Program Bulletin

CUSTOMER SATISFACTION PROGRAM

SUBJECT: Auxiliary Transmission Cooler Line

MODELS: 2014 Chevrolet Corvette Convertible

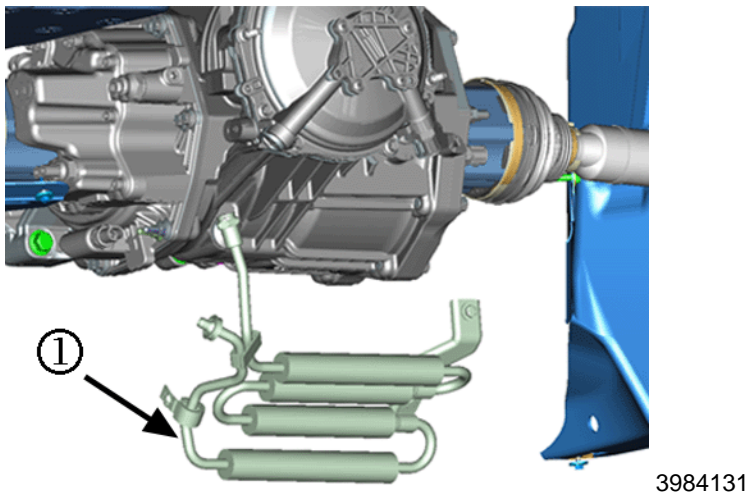
Certain 2014 model year Chevrolet Corvette convertible vehicles have a cooler outlet connector pipe on the auxiliary transmission cooler that may not be properly sealed to its mating connection. The improper seal may cause transmission oil to leak or, under certain conditions, the connector pipe to disconnect from the mating connection. The disconnection of the connector pipe may result in a loss of vehicle propulsion, and leaking transmission oil could cause smoldering if it contacts the heated intake exhaust pipes or mufflers.

Dealers are to replace the auxiliary transmission cooler assembly.

1. Remove the transmission fluid auxiliary cooler (1). Refer to *Transmission Fluid Auxiliary Cooler Replacement (MEL / MEP Convertible) or (MYC Convertible)* in SI.
2. Install the new transmission fluid auxiliary cooler. Refer to *Transmission Fluid Auxiliary Cooler Replacement (MEL / MEP Convertible) or (MYC Convertible)* in SI.
